| Illinois Tollway Standard Drawings Revisions |

| Section L Fiber Optic | |
| | Effective: 03-01-2024 |
| L1-06 | Fiber Optic System Typicals and Drawings |

TYPICAL ROAD CROSSINGS

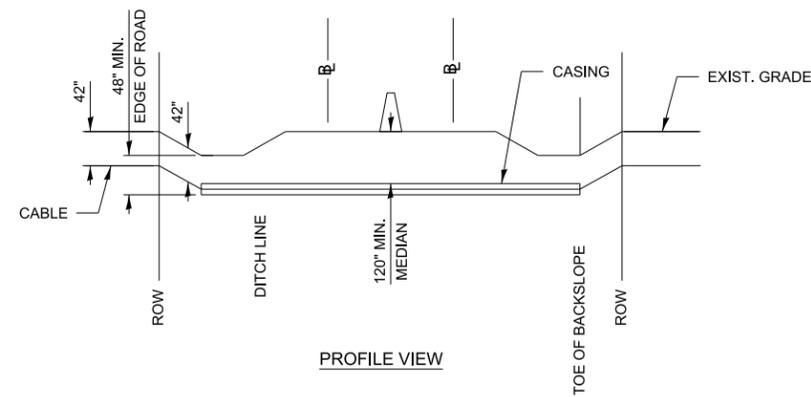
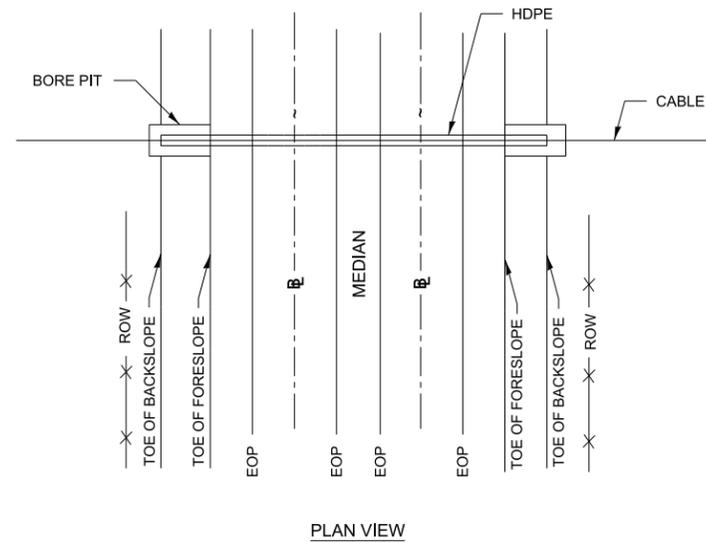
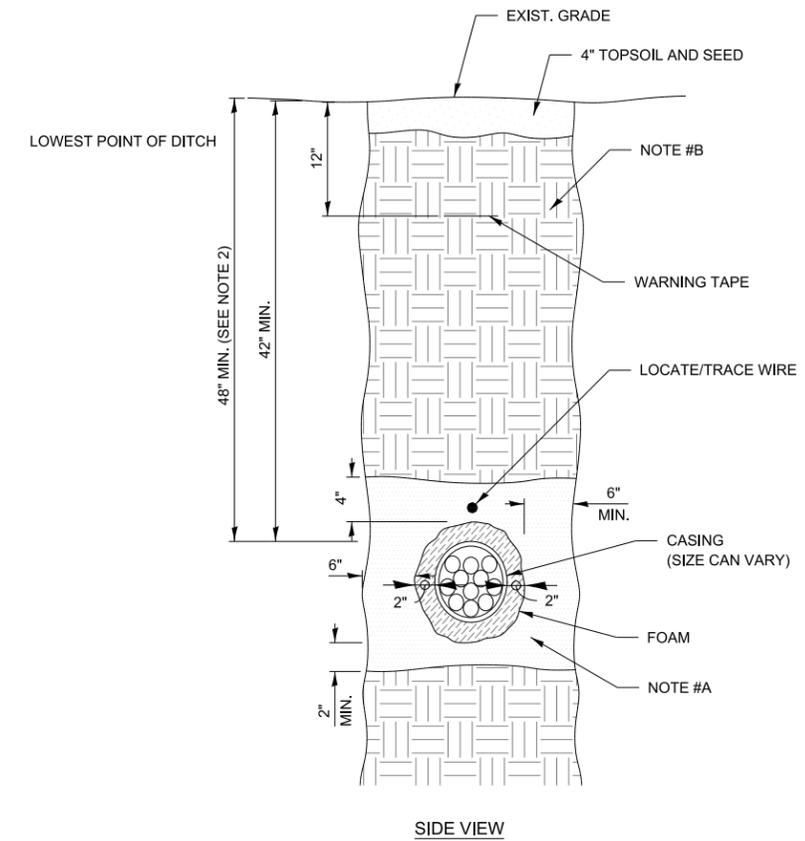
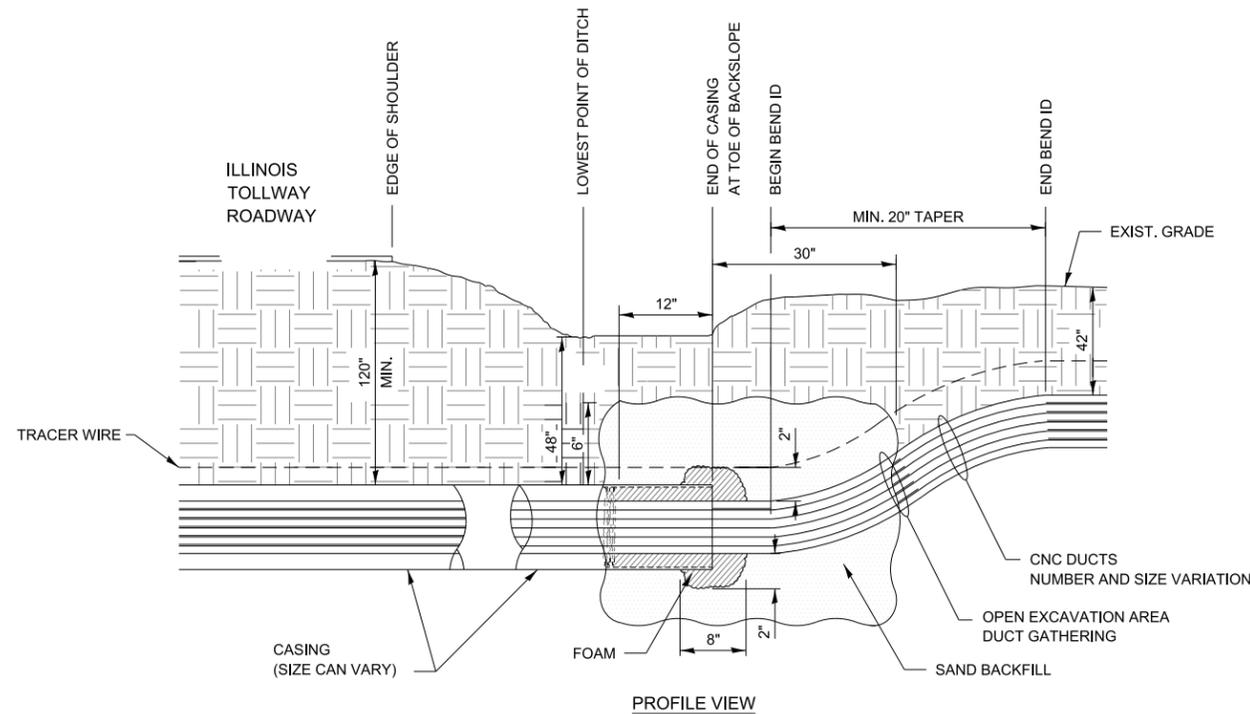
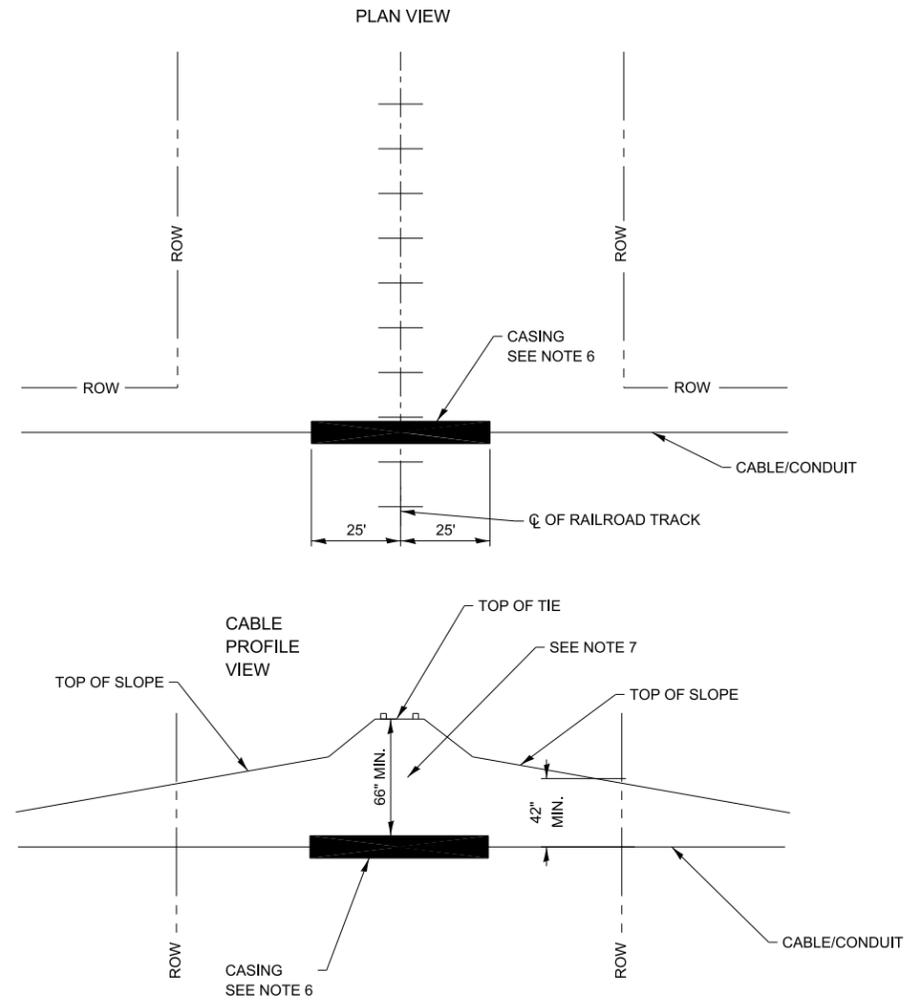
| Section L Fiber Optic | |
|---|---|
| Sheet 2 | Removed note "Top casing shall be a min of 120" below lowest Illinois Tollway road surface". |
| | Modified profile view to include tracer wire. |
| | Removed "DAM" call out from profile view. |
| | Added Note 12. |

UTILITY AVOIDANCE DETAIL

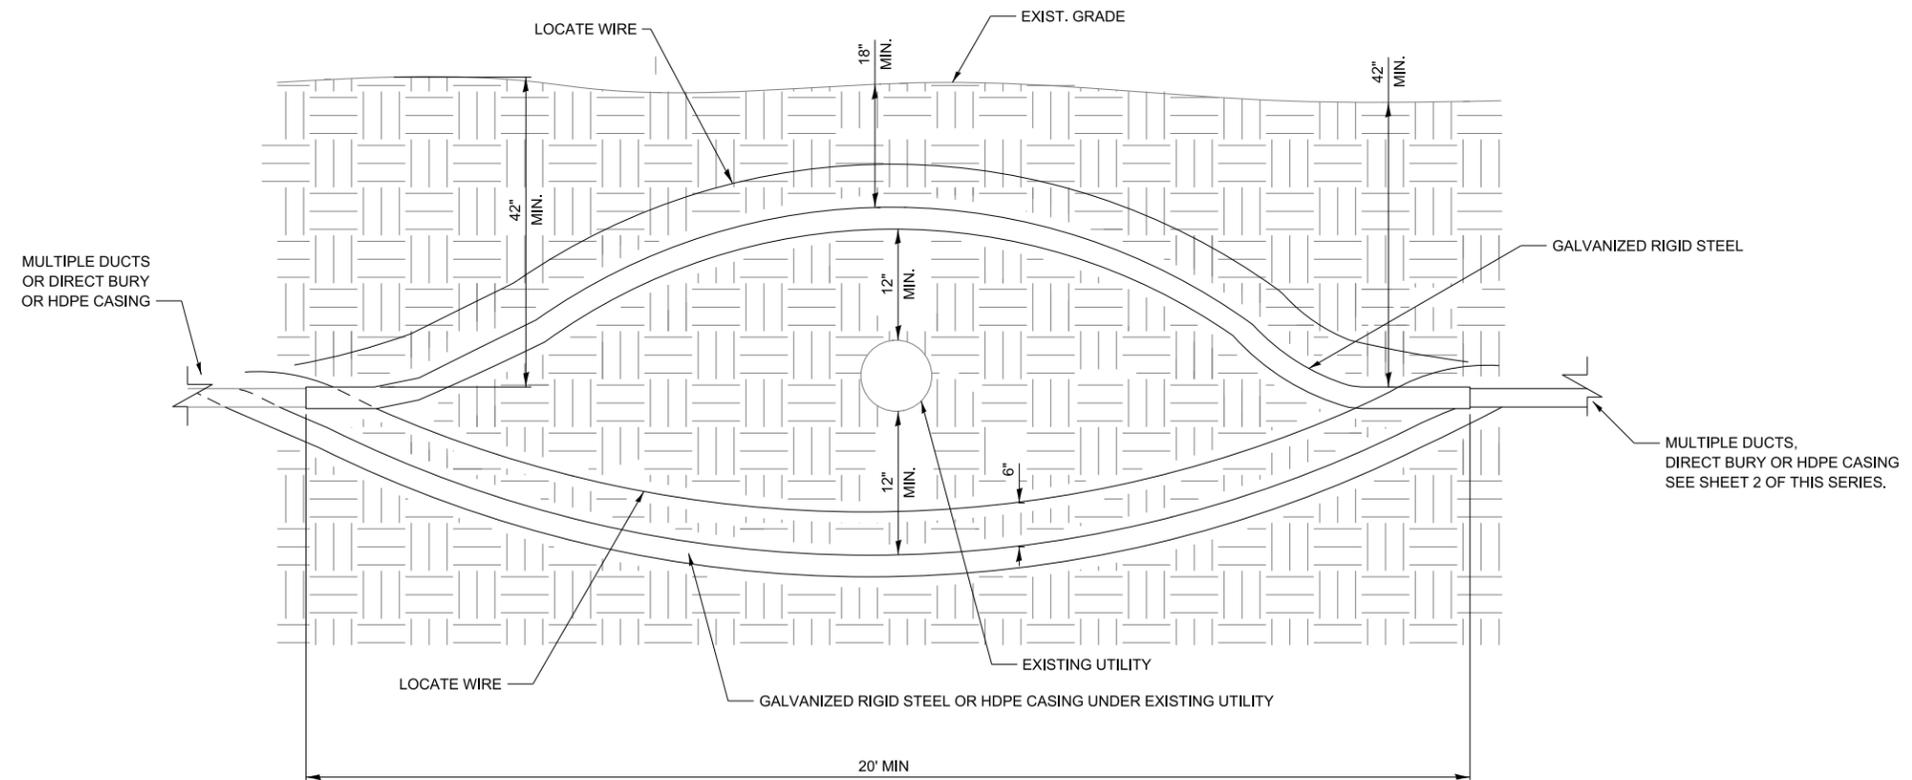
| Section L Fiber Optic | |
|---|---|
| Sheet 4 | Modified detail to include locate wire. |

HANDHOLE

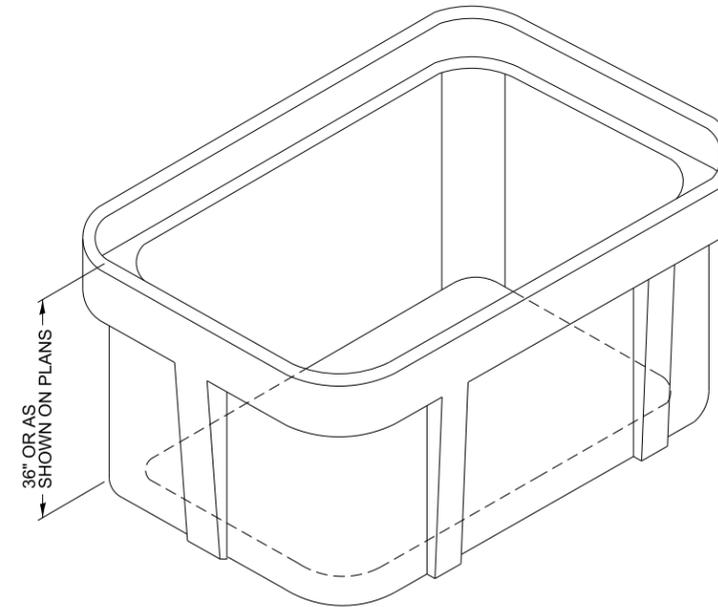
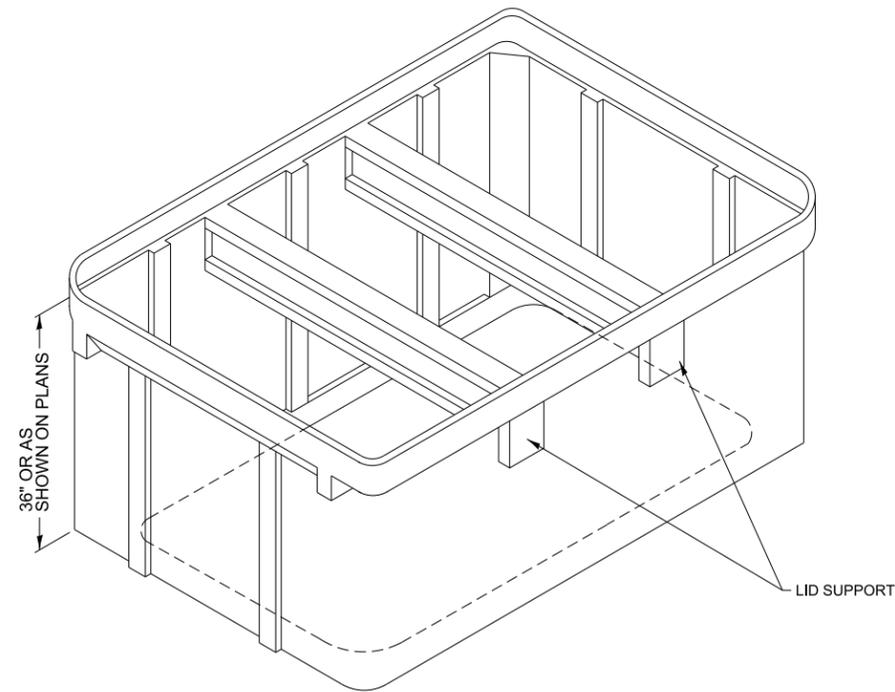
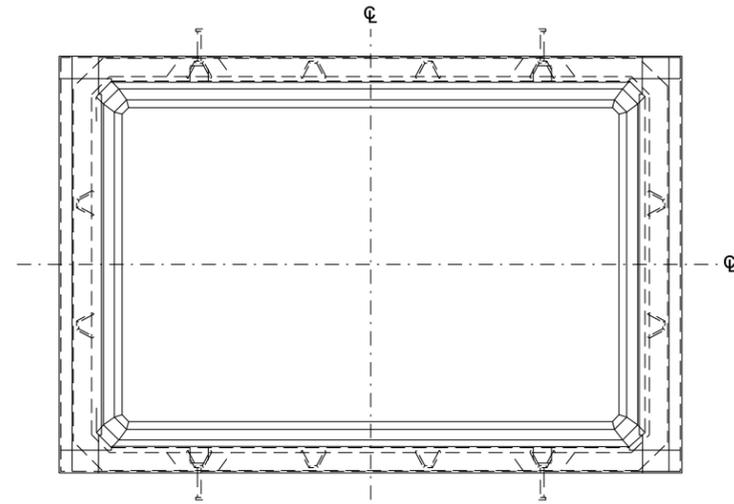
| Section L Fiber Optic | |
|---|---|
| Sheet 6 | Removed note "No marking on lid". |
| | Removed "Standard Marking" call out. |
| | Removed the 2-section split lid from the 48"x72" detail. |

HDPE AND FIBER OPTIC CABLE PLACEMENT IN HANDHOLE

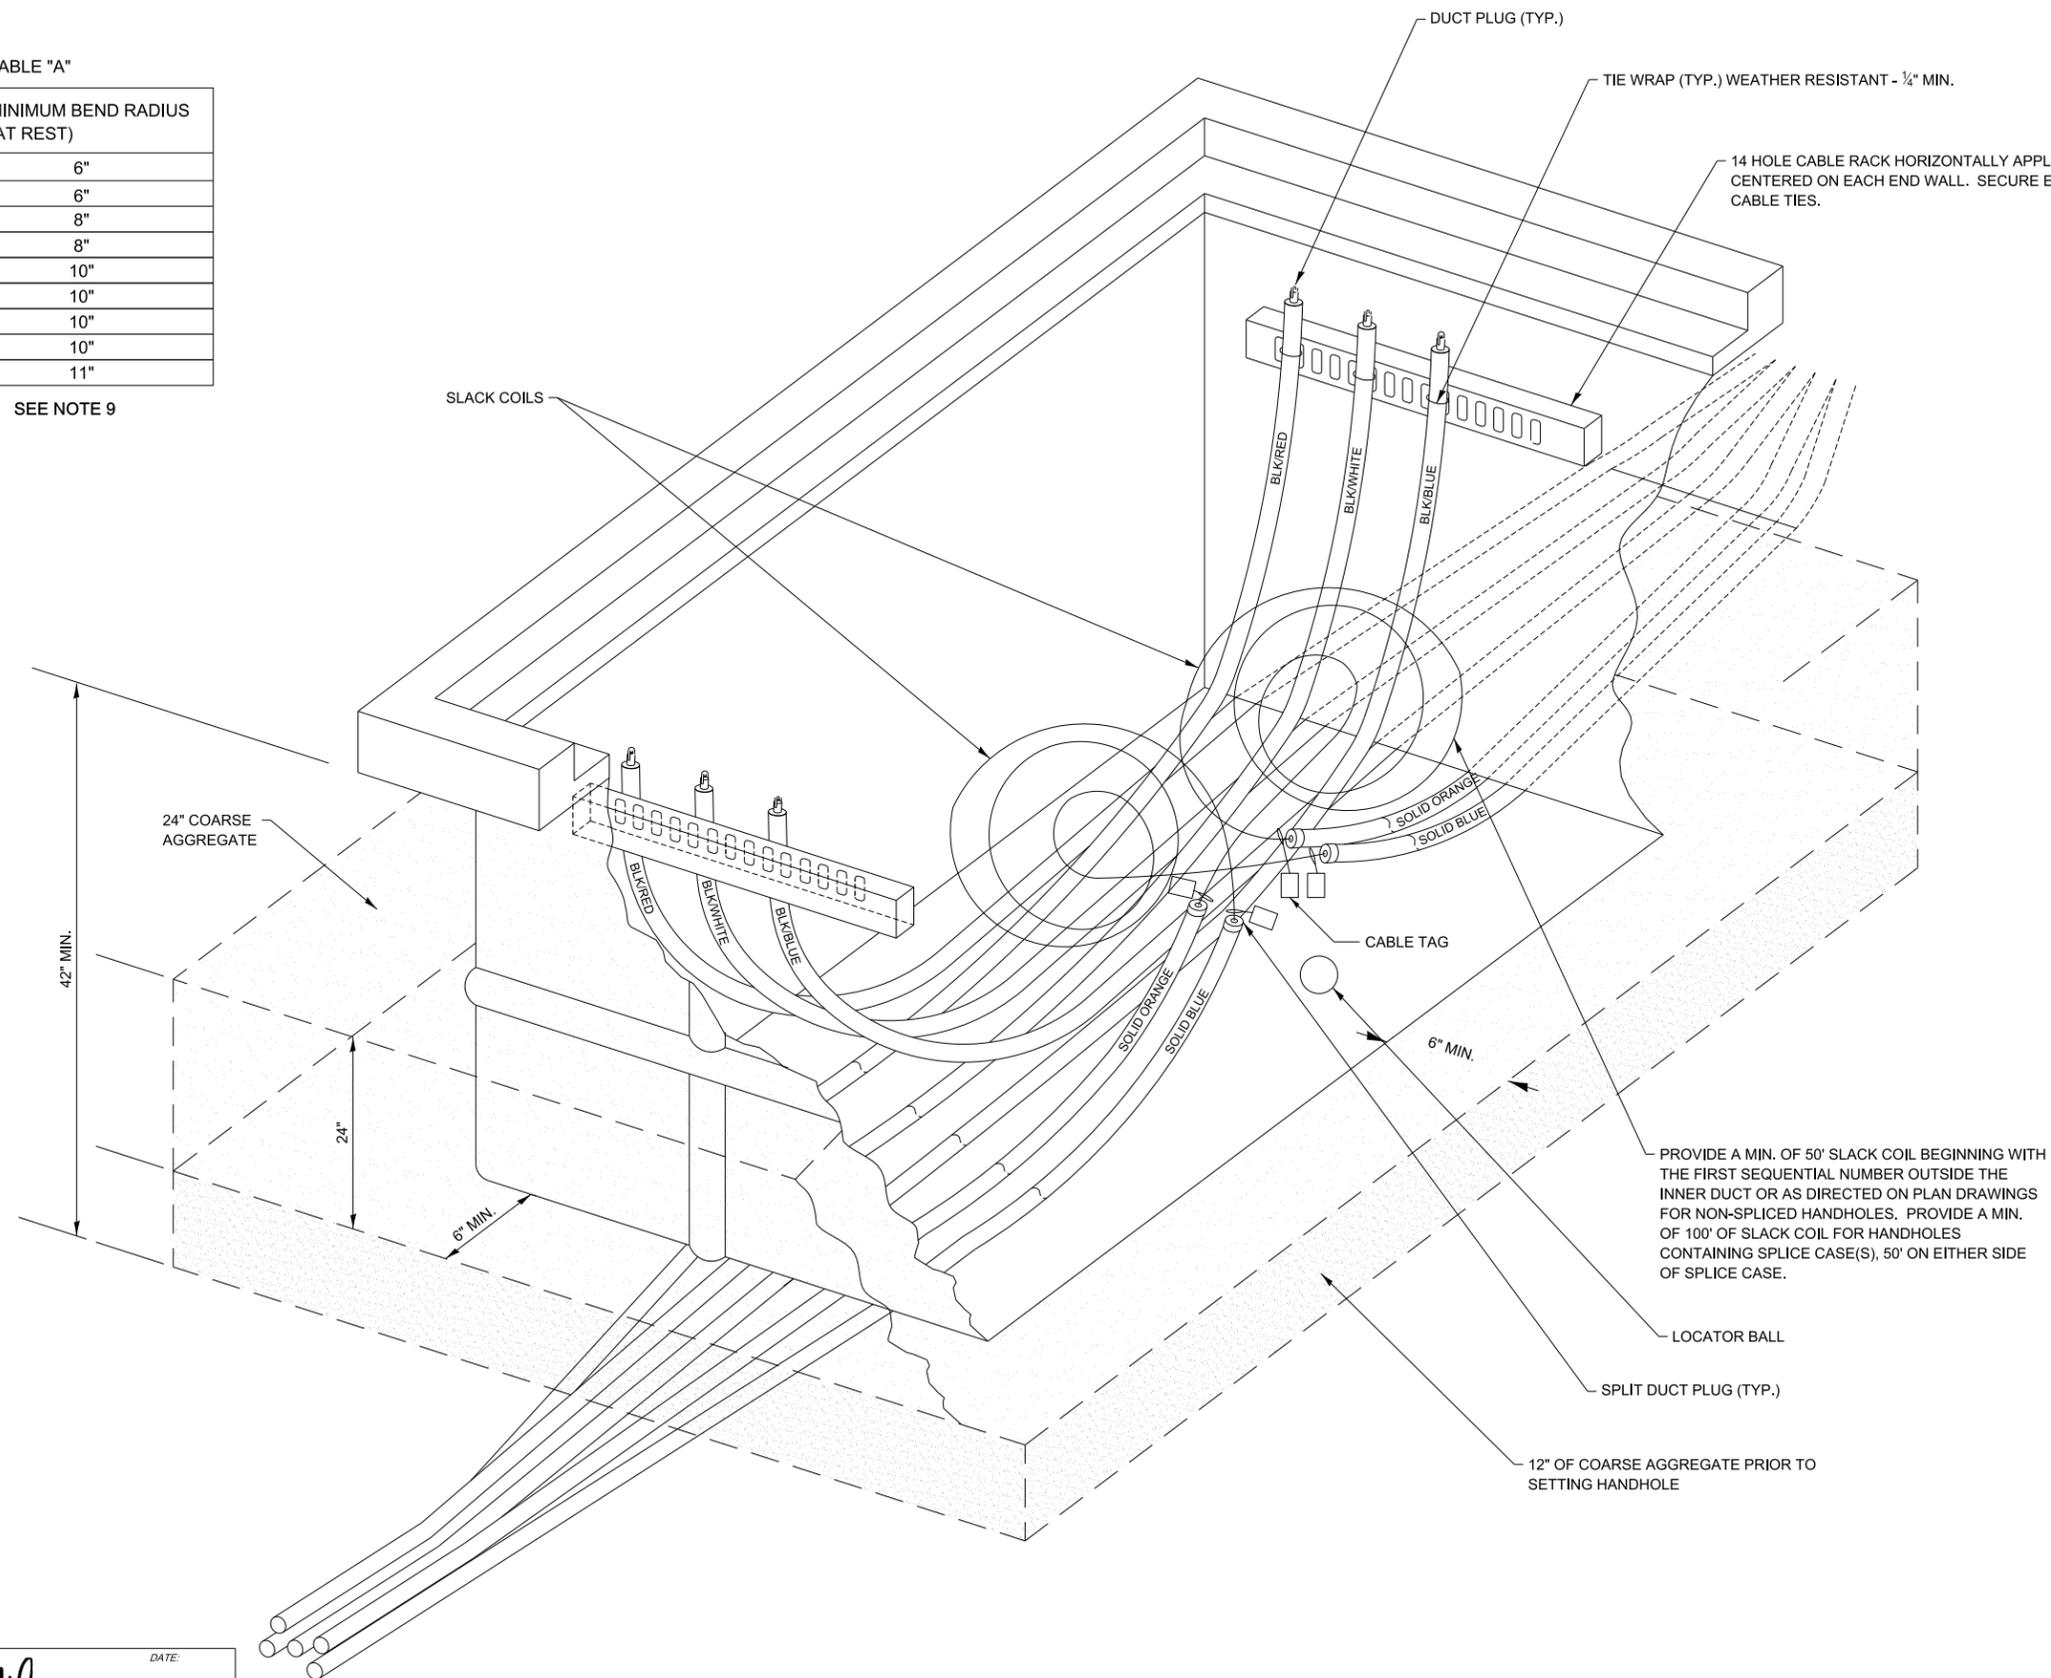
| Section L Fiber Optic | |
|---|---|
| Sheet 8 | Replaced "Pea Gravel" callout with "Coarse Aggregate". |
| | Adjusted "42" Min" measurement call out. |
| | Removed note "Fiber coil bundle shall be labeled with owner, end locations, fiber type, and fiber count". |
